APPLICATION NO.	FILING DATE	FIRST NAMED INVENTOR	ATTORNEY DOCKET NO.	CONFIRMATION NO.
10/723,974	11/26/2003	William Todd Hurst	5703-00059	9503
7590	11/30/2005			
Dinnin & Dunn, P.C. Suite 500 2701 Cambridge Ct. Auburn Hills, MI 48326			EXAMINER CULBRETH, ERIC D	
			ART UNIT	PAPER NUMBER
			3616

Office Action Summary

INSTRUMENT PANEL ADAPTER FOR AIRBAG MOUNT

Replacement Drawings filed on 09/09/05

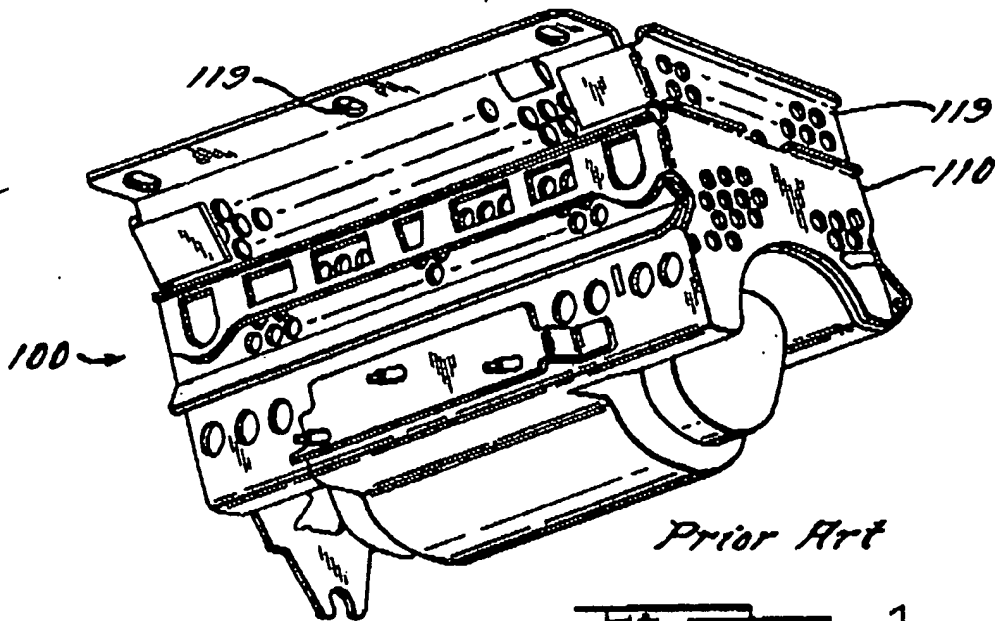
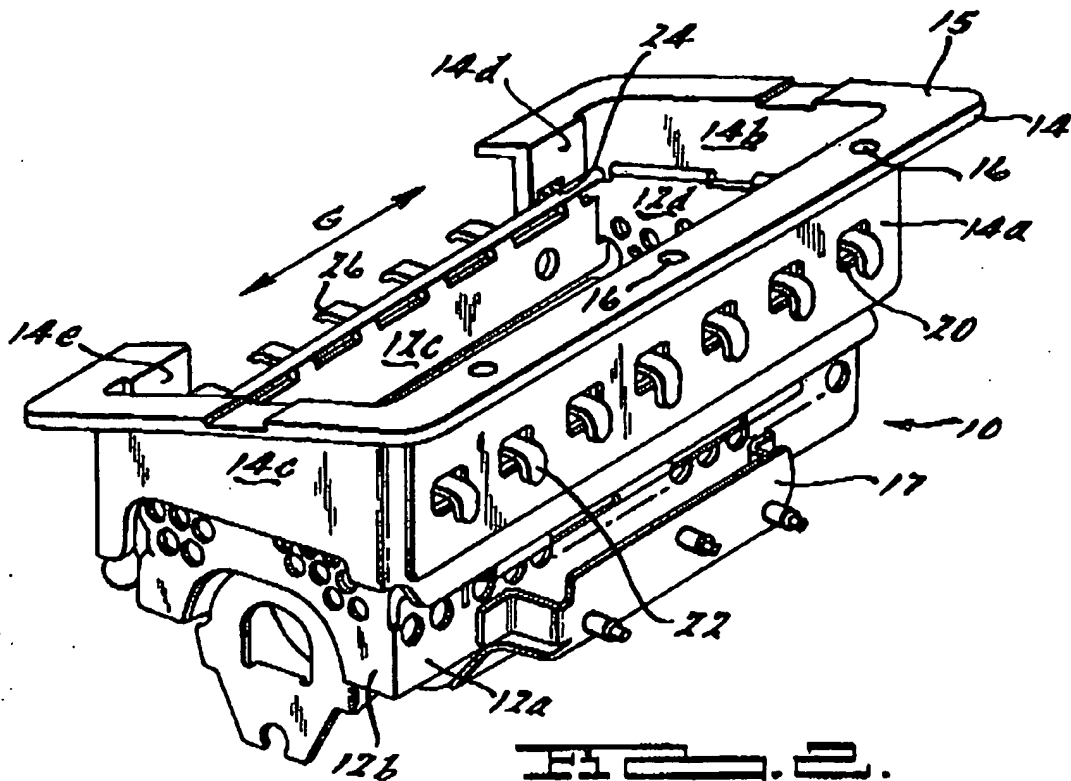
1. The drawings were received on 9/9/05. These drawings are not approved.

No brief description of Figure 4 was added to the specification. Also, the structure shown for the first time in Figure 4 (the shape of members 32, 36, etc.) constitute new matter. The examiner suggests adding a brief description of Figure 4 to the specification on page 2 and stipulating in that brief description that Figure 4 is a "schematic" representation (i.e., for illustrative purposes only; not conveying any specific structure of the invention).

Drawings not
approved
EL
11/19/05
